SERVICE LETTER NUMBER 27

REFERENCE: AD 82-27-03 (Effective December 30, 1982)

SUBJECT: Rajay Turbocharger Model 325E10
Inspection of Turbocharger Turbine
Housings P/N TC-60-11 and/or
600510-01, 600510-02.

SERVICE LETTER 27A ADDENDUM

FIG. 1

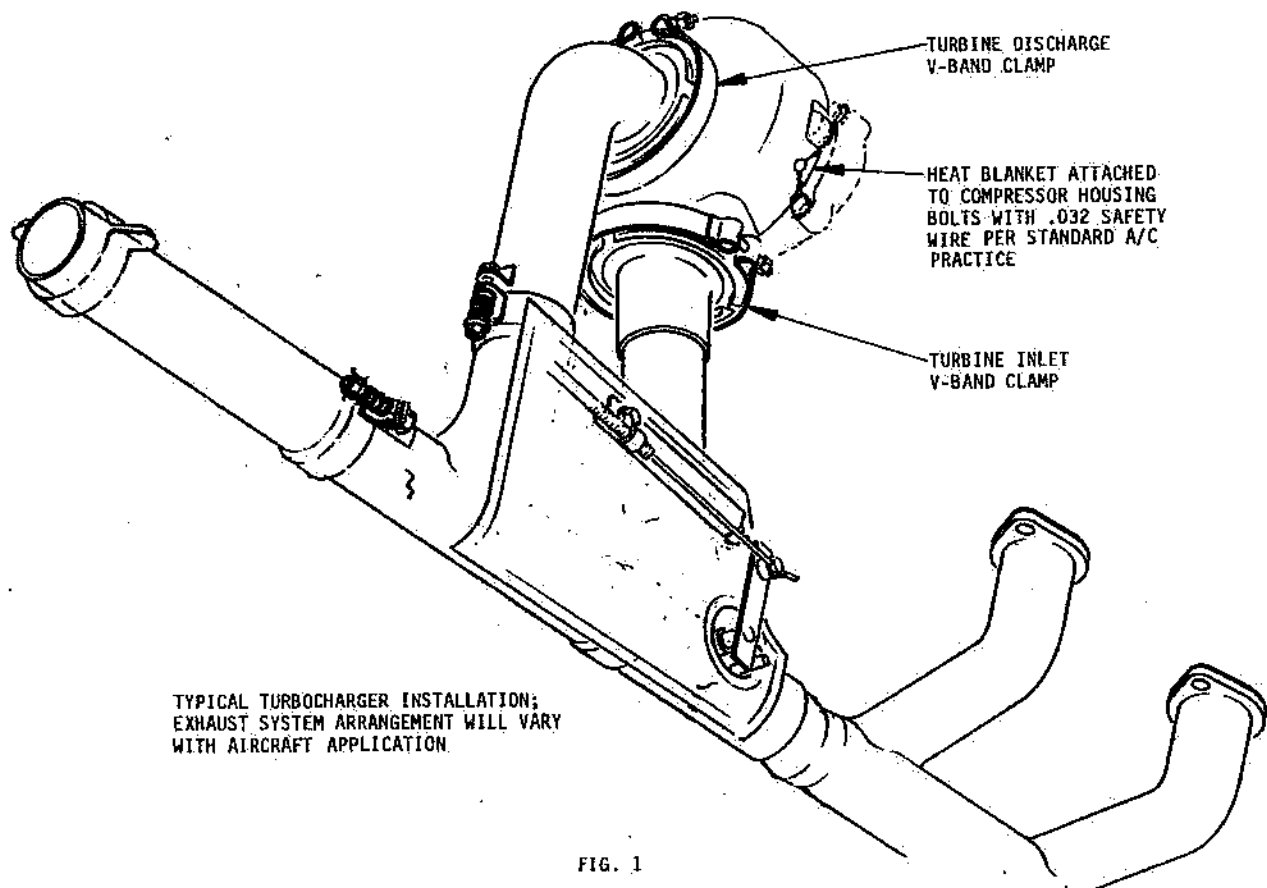
In certain aircraft installations, it may be possible to inspect the turbine housing inner and outer walls for penetrating cracks per Views 1 and 3, without removal of the turbocharger from the aircraft. In any event, the exhaust manifold must be disconnected from the coupling V-band so that the turbine housing internal area near the nozzle can be seen as shown in View 2. If a thermal blanket is installed on the turbine housing, it must be removed. (See Figure 1.)

1. Remove the turbine housing blanket (if installed). (See Figure 1.)
2. Disconnect the exhaust manifold by removing the coupling V-bands.
3. Make "index marks" on the turbine housing and on the aluminum bearing housing so the turbine housing will be reinstalled in the same correct rotational position.
4. Remove the V-band nut and carefully remove the bearing housing V-band (P/N 600391).
5. Remove the turbine housing from the bearing housing and inspect per Description A.1. and 2. Light tapping at the joint with a rawhide mallet will help separate them.
6. While the housing is off, inspect the turbine wheel and heat shield for condition and/or foreign object damage.

TYPICAL TURBOCHARGER INSTALLATION;
EXHAUST SYSTEM ARRANGEMENT WILL VARY
WITH AIRCRAFT APPLICATION.
